CITY OF SOUTH ST. PAUL MEETING AGENDA

PLANNING COMMISSION

PLANNING COMMISSION AGENDA REPORT

Site Plan Review and Conditional Use Permits for AVR LLC Concrete Batch Plant Project at 400 Richmond Street East

ATTACHMENT 8 LANDSCAPE PLAN

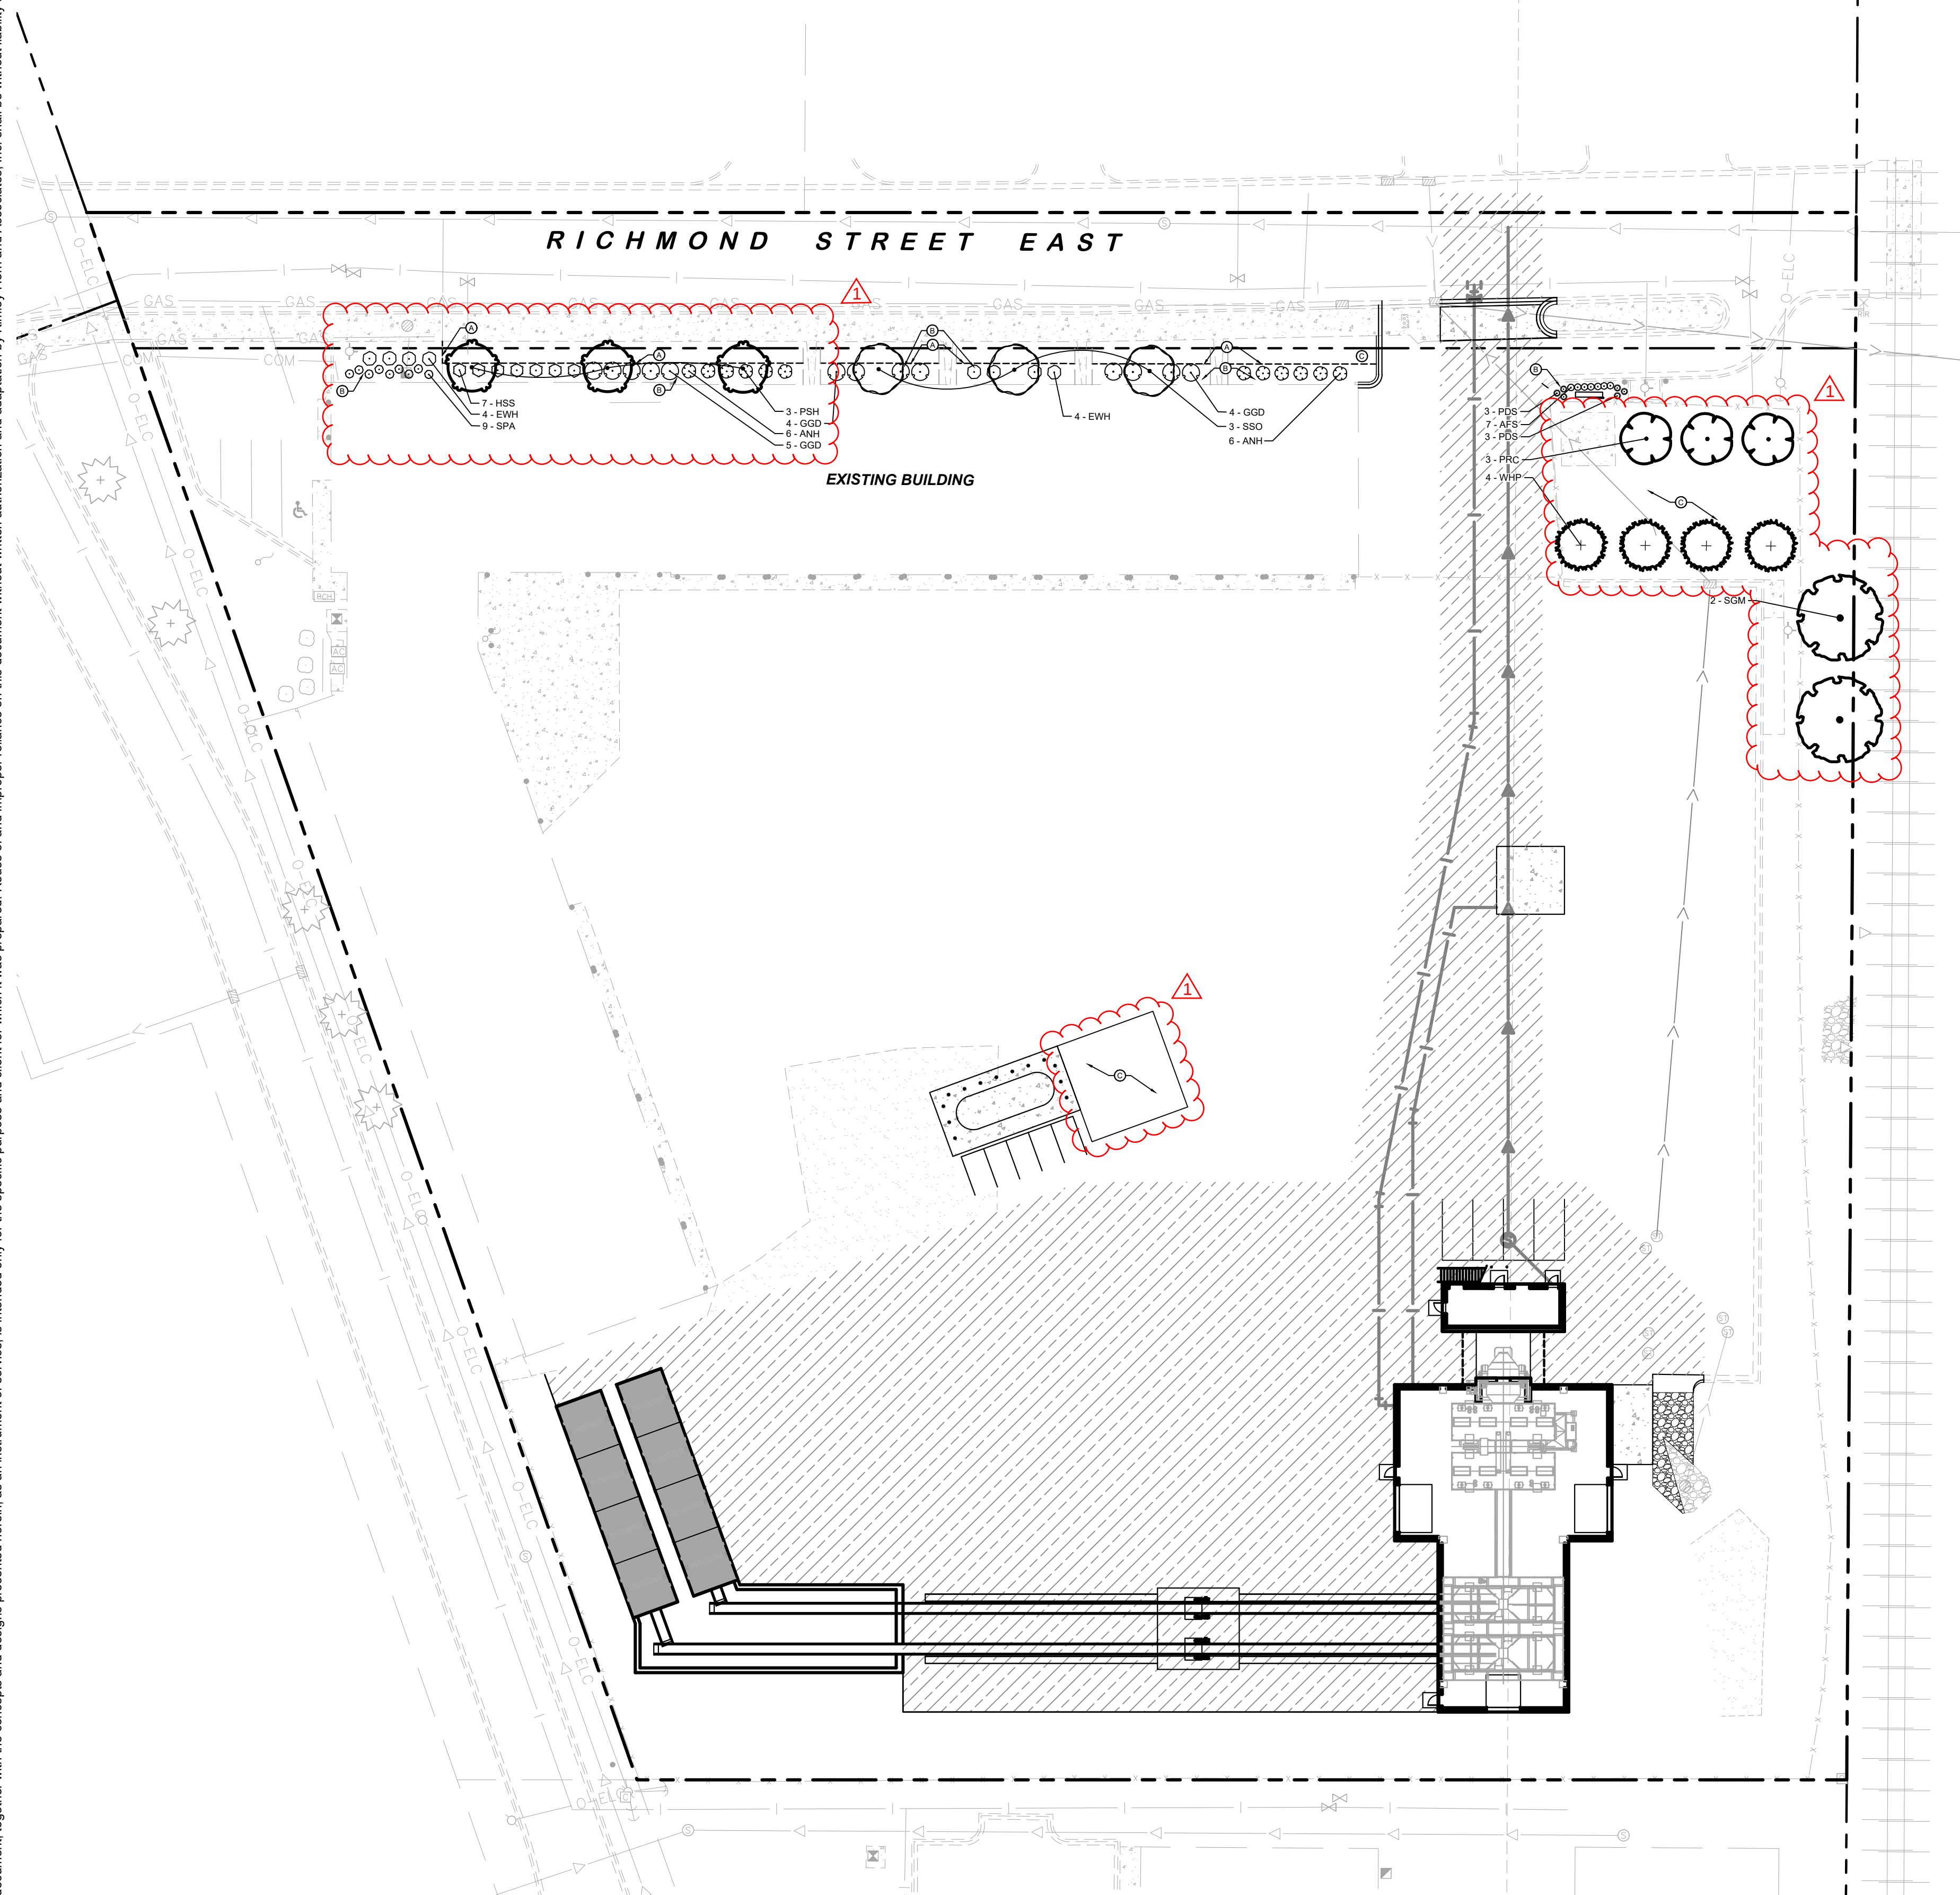
The Applicant is proposing to plant 15 overstory trees on the subject property with a focus on beautifying the Richmond Street side of the property. This would be a partial satisfaction of the 26-tree requirement for a new development. City Staff has encouraged the Applicant to come as close to meeting the 26-tree requirement as possible with the understanding that the site's layout may prevent full compliance. The Applicant's proposal seems reasonable.

The Applicant is currently proposing to plant two maple trees along the eastern property line. Maple trees have large canopies and would interfere with the Union Pacific railroad tracks to the east, which would necessitate aggressive pruning that would kill the trees. The two maple trees need to be replaced with conical tree varieties that will grow straight up and will not have a large canopy.
